AUTOMATIC TRANSMISSION

OUTLINE OF CHANGES

The following service procedures for items which are different from before have been established to correspond to the following changes:

SHIFT PATTERN

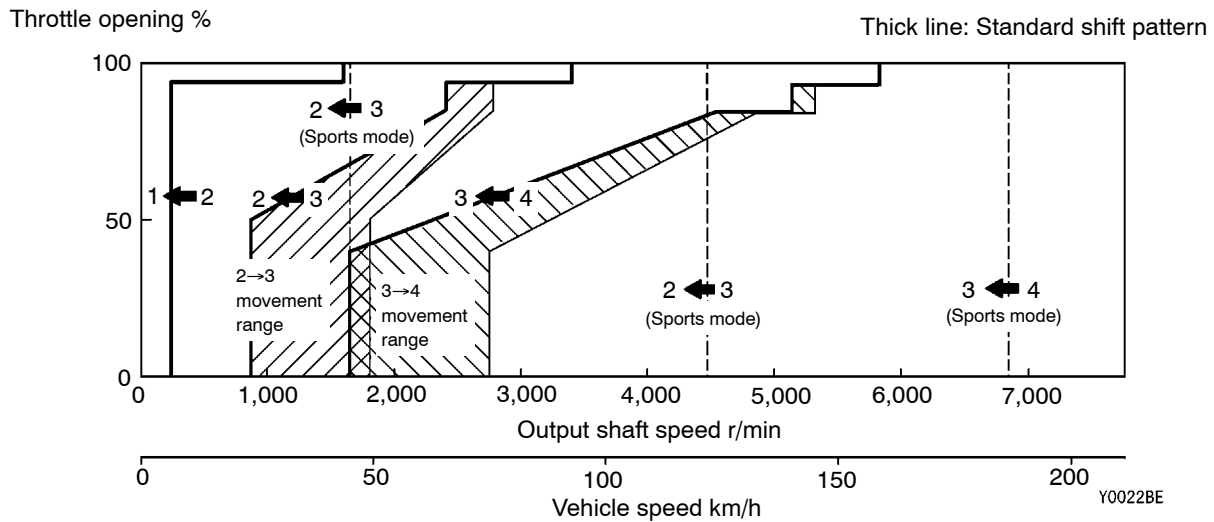
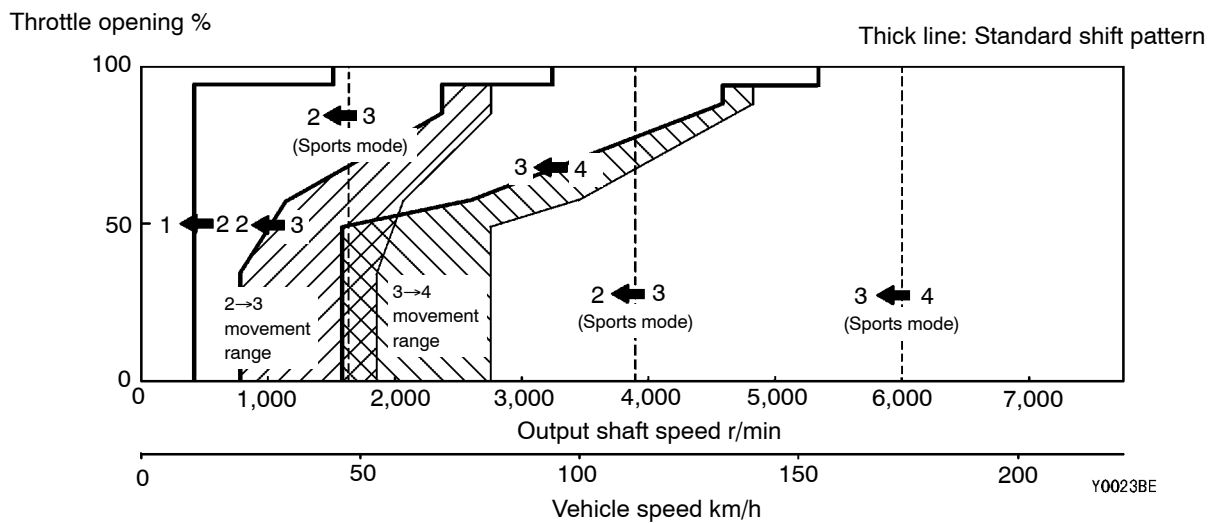
The downshift pattern of 4G63, 4G64 engine vehicles has been changed.

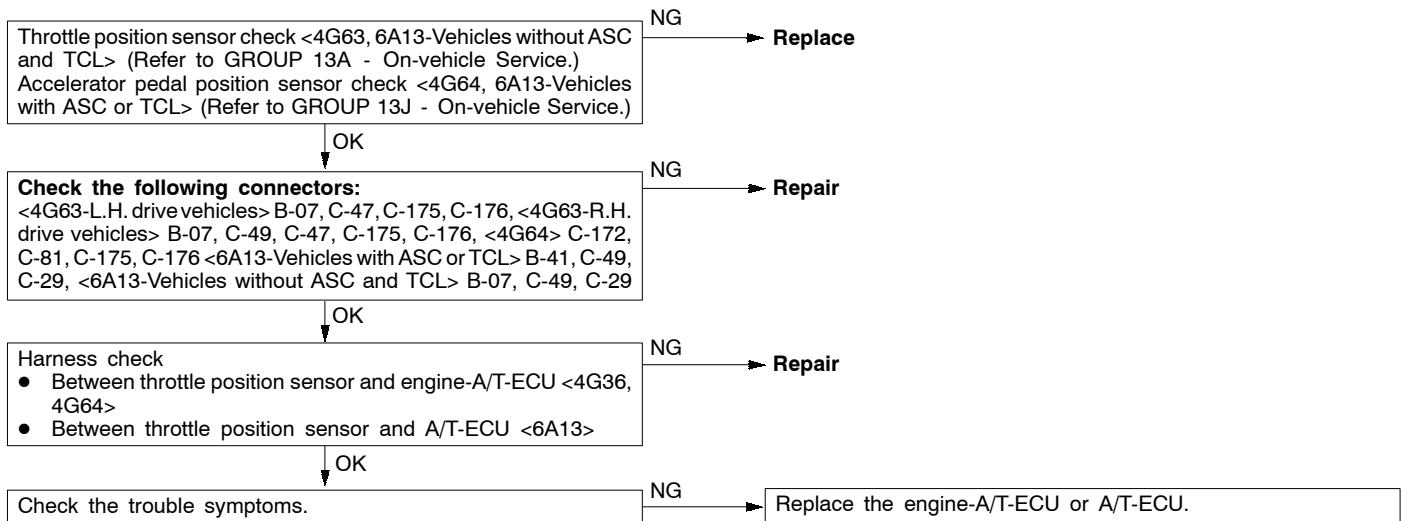
Code No. 11, 12, 14 Throttle position sensor system (TPS) <4G63, 6A13-Vehicles without ASC and TCL>, Accelerator pedal position sensor (APS) <4G64, 6A13-Vehicles with ASC or TCL>	Probable cause
<p>If the TPS or APS output voltage is 4.8 V or higher when the engine is idling, the output is judged to be too high and diagnosis code No. 11 is output. If the TPS or APS output voltage is 0.2 V or lower at times other than when the engine is idling, the output is judged to be too low and diagnosis code No. 12 is output. If the TPS or APS output voltage is 0.2 V or lower or if it is 1.2 V or higher when the engine is idling, the TPS or APS adjustment is judged to be incorrect and diagnosis code No. 14 is output.</p>	<ul style="list-style-type: none"> ● Malfunction of the throttle position sensor <4G63, 6A13-Vehicles without ASC and TCL > ● Malfunction of the accelerator pedal position sensor <4G64, 6A13-Vehicles with ASC or TCL> ● Malfunction of connector ● Malfunction of the engine-A/T-ECU <4G63, 4G64> ● Malfunction of the A/T-ECU <6A13>

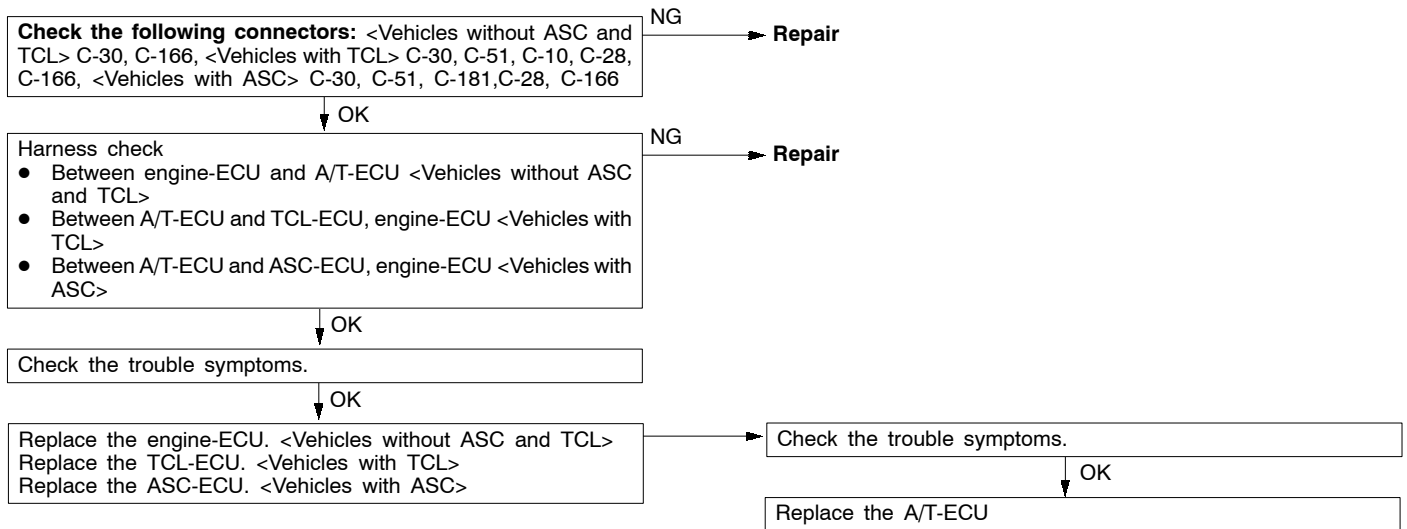
Code No. 51 Abnormal communication with engine-A/T-ECU <4G63, 4G64>, Abnormal communication with engine-ECU <6A13-Vehicles without ASC and TCL>, Abnormal communication with TCL-ECU and engine-ECU <6A13-Vehicles with TCL>, Abnormal communication with ASC-ECU and engine-ECU<6A13-Vehicles with ASC>	Probable cause
If normal communication is not possible for a continuous period of 1 second or more when the ignition switch is at the ON position, the battery voltage is 10 V or more and the engine speed is 450 r/min or more, diagnosis code No. 51 is output. Diagnosis code No. 51 is also output if the data being received is abnormal for a continuous period of 4 seconds under the same conditions.	<ul style="list-style-type: none"> ● Malfunction of connector ● Malfunction of the engine-A/T-ECU <4G63, 4G64> ● Malfunction of the A/T-ECU <6A13> ● Malfunction of the engine-ECU <6A13> ● Malfunction of the TCL-ECU <6A13-Vehicles with TCL> ● Malfunction of the ASC-ECU <6A13-Vehicles with ASC>

Replace the engine-A/T-ECU
